ZIONSVILLE PLAN COMMISSION MEETING RESULTS

Tuesday, February 18, 2020

ZIONSVILLE PLAN COMMISSION
Docket Number 2019-52-Z
4255 S 300 E

SITE DEVELOPMENT PLAN

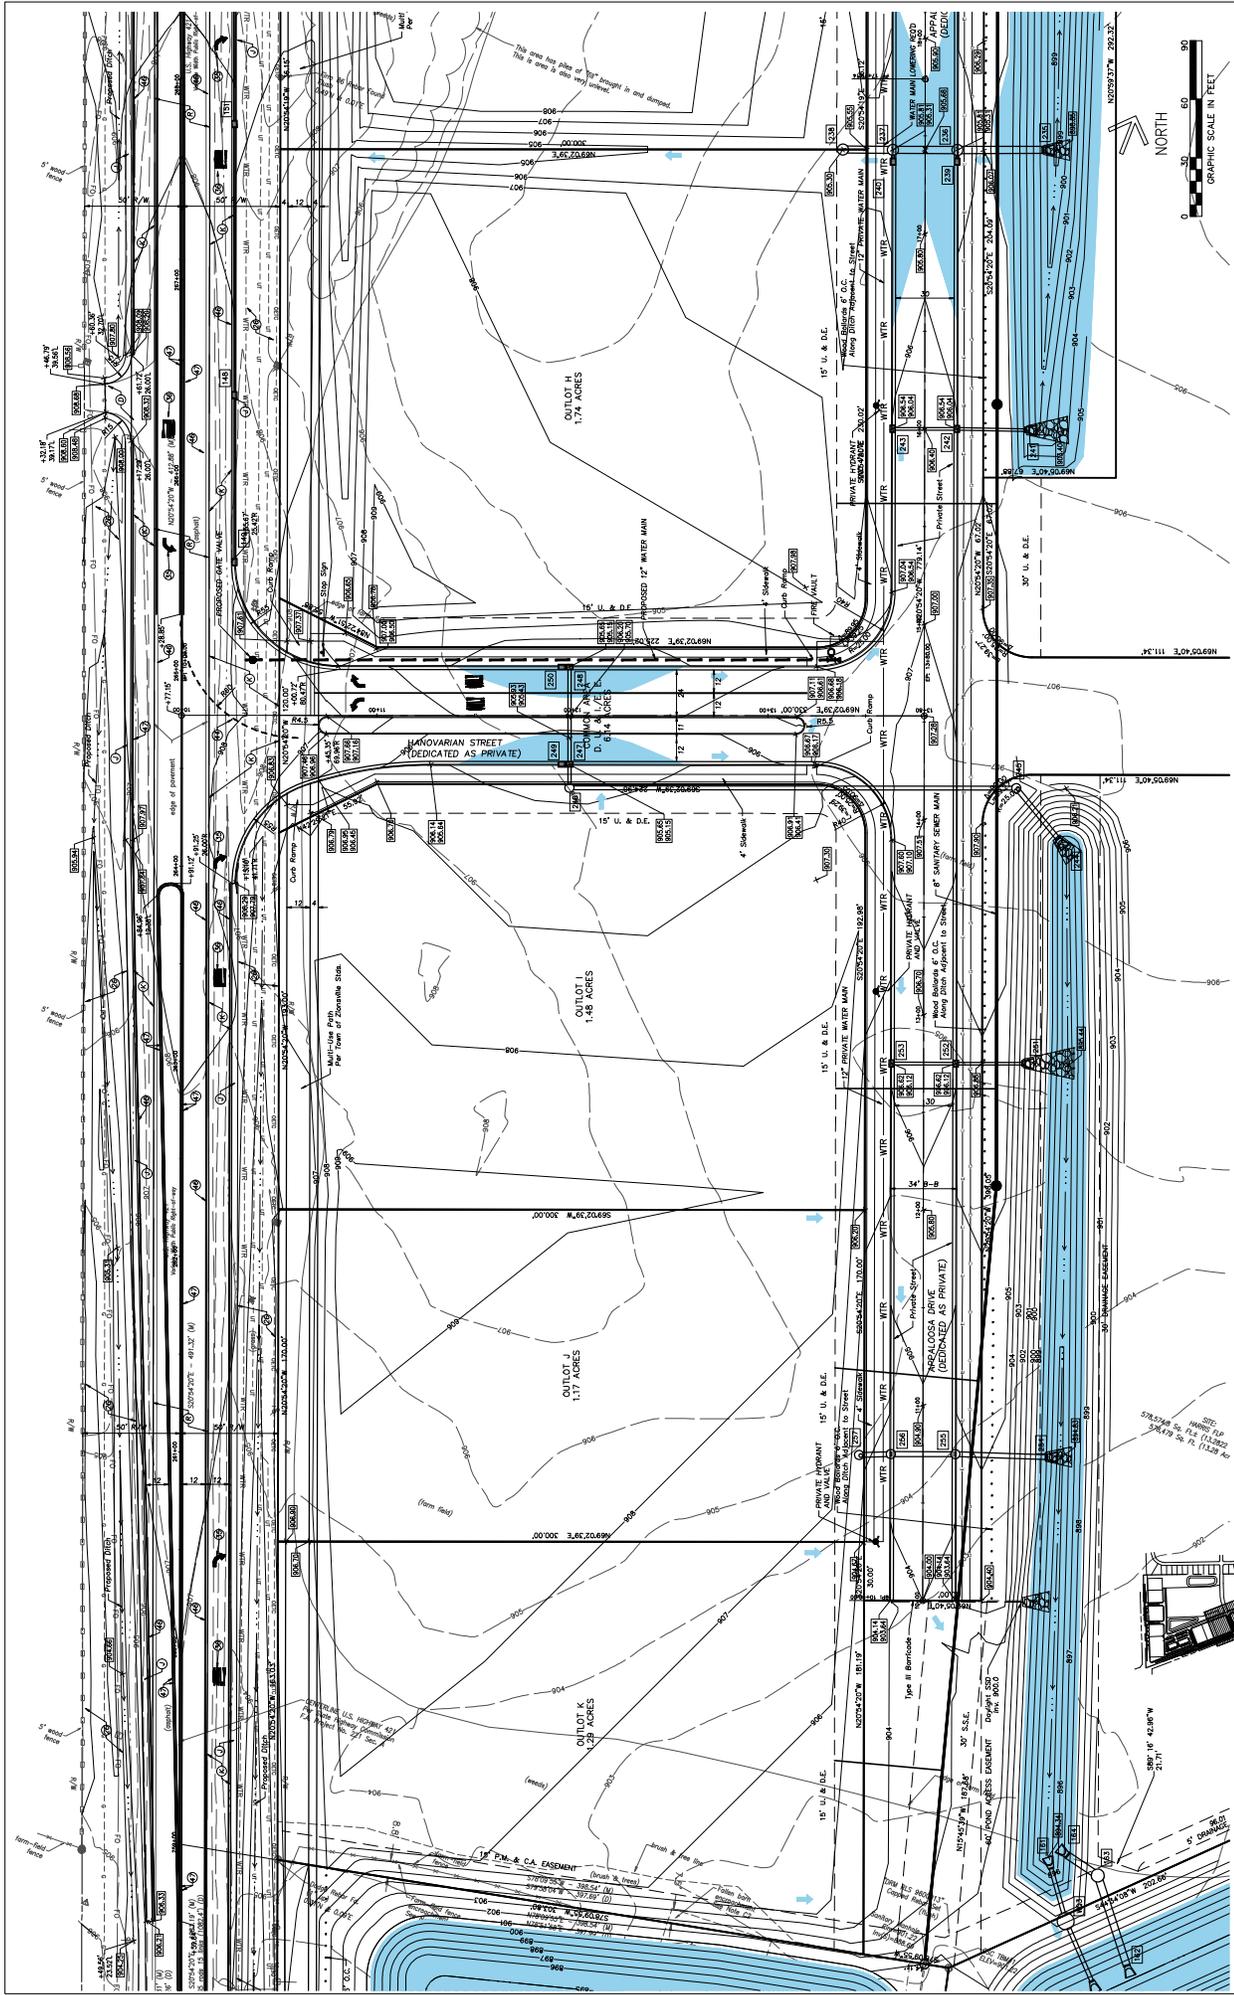
II. Offsite contours on Sheet 6 of the overall site development plans are not sufficiently labeled to determine and assess topography.
